ENGINEERING CHANGE NOTICE

1. ECN ~~472792~~

5. Project Title/No./Work Order No. B-714/ER8007

Grouted Waste Disposal Facilities

Ref. Dwg.	Sh.	Rev.	Prepared By	Checked By	ECN No.	Page
H-2-77599	1	1	D. McDORMAN	M.A. McLean	B-714-122	6/8
H-2-78470	1	0

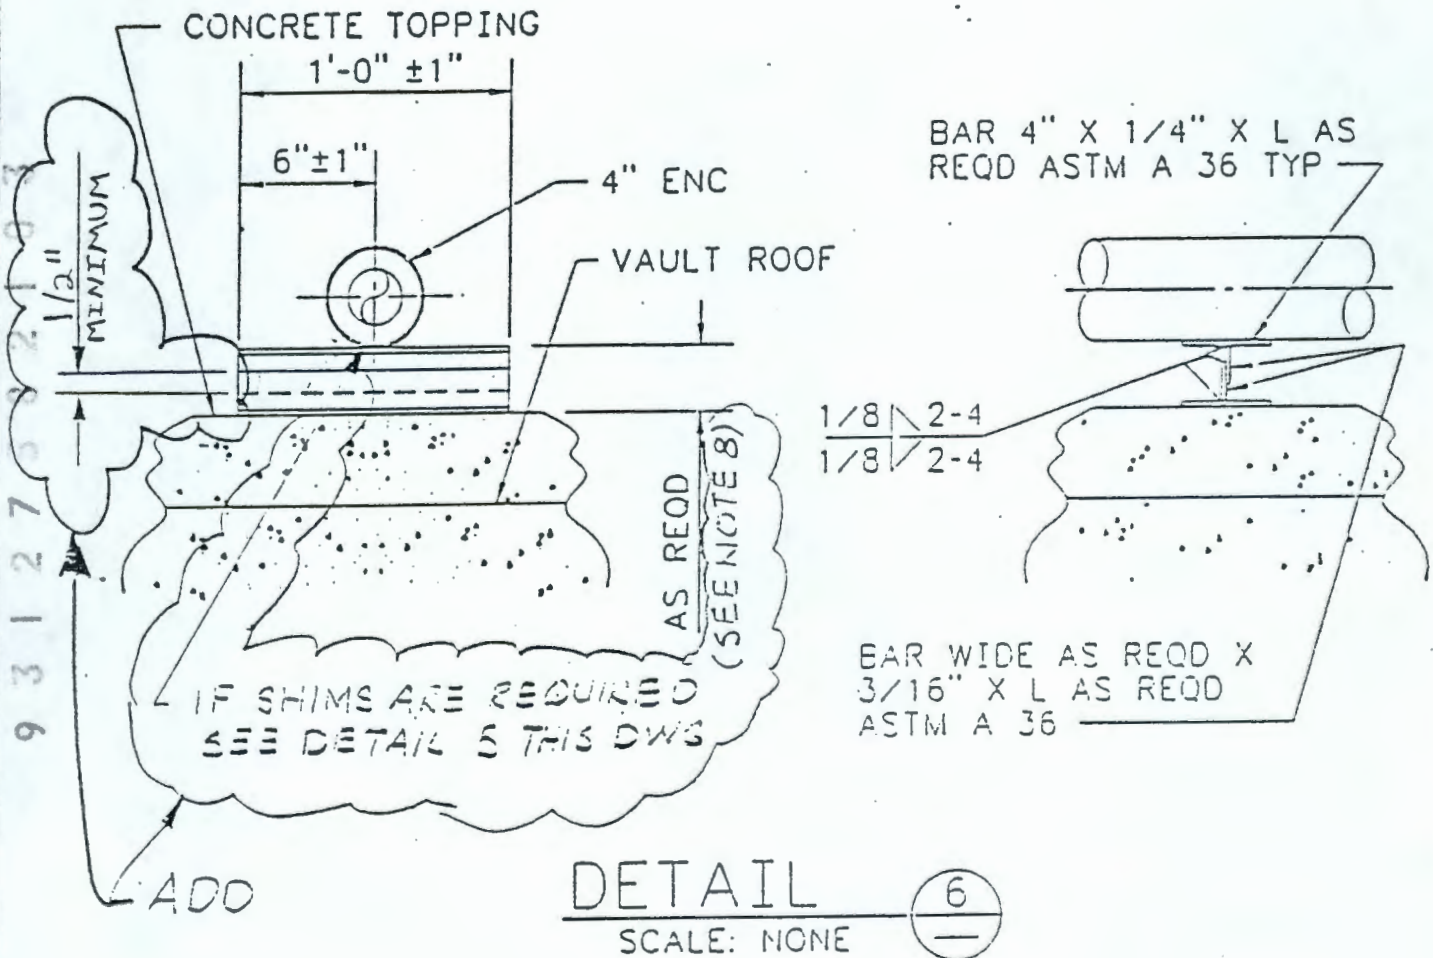
- A) Detail 5: Replace old detail with new detail as shown on page 5 of this ECN. (Affects ECN B-714-93, page 1, item 3B).
- B) Detail 6: Add "SEE NOTE 8", shim callouts & overlap dimension as shown on page 6 of this ECN. (Affects ECN B-714-93, page 4).

- A) Detail 5: Replace old detail with new detail as shown on page 5 of this ECN. (Affects ECN B-714-93, page 3, item 7B).
- B) Detail 6: Add "SEE NOTE 8", shim callouts & overlap dimension as shown on page 6 of this ECN. (Affects ECN B-714-93, page 4).
- C) Detail 7: Add new detail as shown on page 7 of this ECN.
- D) Detail 8: Add new detail as shown on page 8 of this ECN.
- E) Notes:
- Change Note 7 to read: CONCRETE BASE SUPPORTS ON SOIL SHALL BE ...
 - Add new Notes 8, 9, & 10 as follows:

Ref. Dwg.	Sh.	Rev.	Prepared By	Checked By	ECN No.	Page
H-2-77599	1	1	D. McDORMAN	M. A. McLean	E-714-122	7/8
H-2-78470	1	0

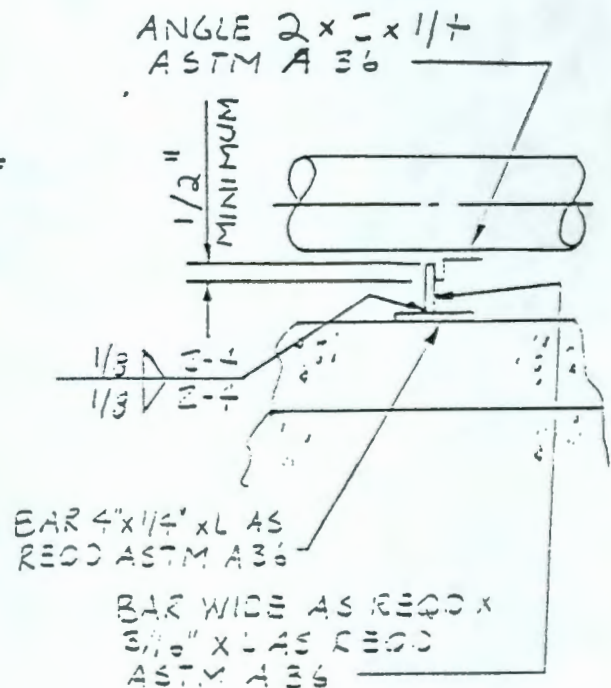
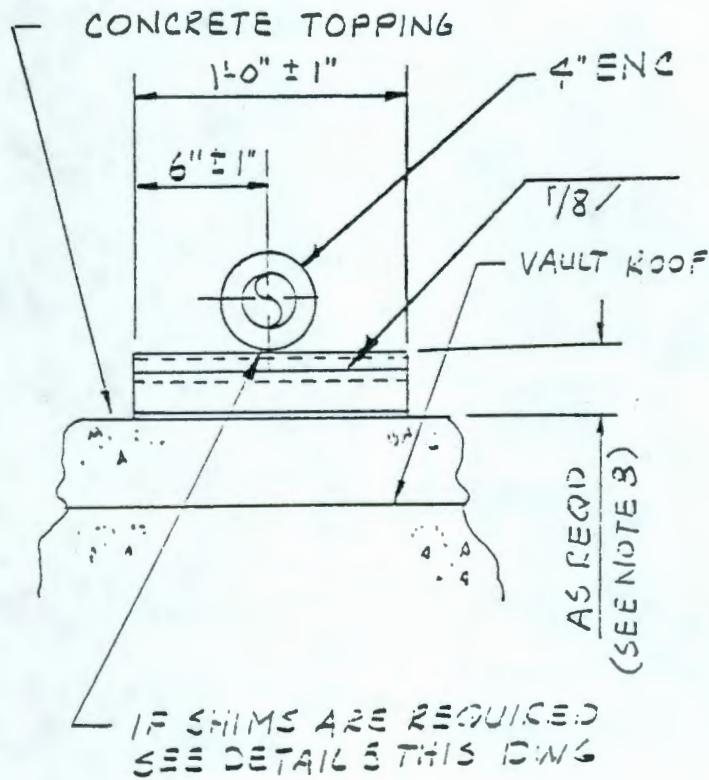
- C) Detail 7: Add new detail as shown on page 7 of this ECN.
- D) Detail 8: Add new detail as shown on page 8 of this ECN.
- E) Notes:
- Change Note 7 to read: CONCRETE BASE SUPPORTS ON SOIL SHALL BE ...

Ref. Dwg.	Sh.	Rev.	Prepared By	Checked By	ECN No.	Page
H-2-77599	1	1	D McDORMAN	M. A. McLean	B-714-122	8/8
H-2-78470	1	0

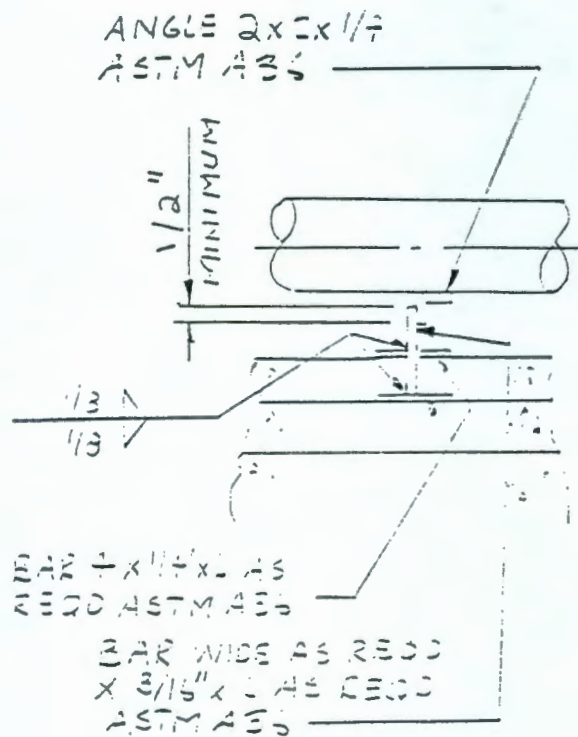
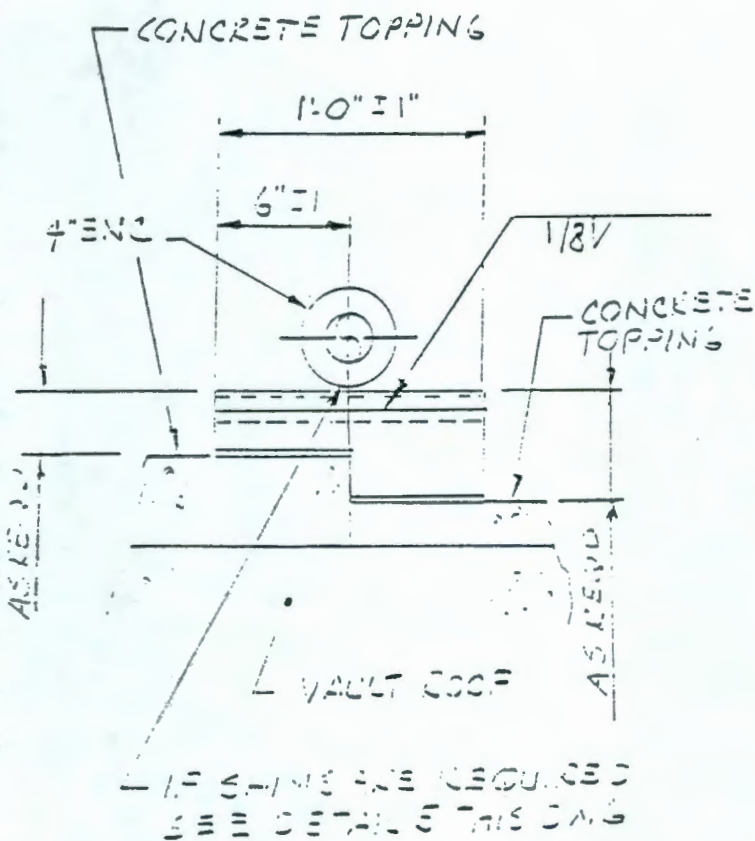
9. USE DETAIL 8 WHERE THE BASE OF A METAL PIPE SUPPORT OVERLAPS ABRUPT ELEVATION CHANGES IN THE TOPPING SLAB.
10. PROVIDE ~~TEMPORARY~~ ^{TEMPORARY} SUPPORT AS REQUIRED TO POSITION PIPE SUPPORT PRIOR TO AND DURING PLACING DIFFUSION MATERIAL.
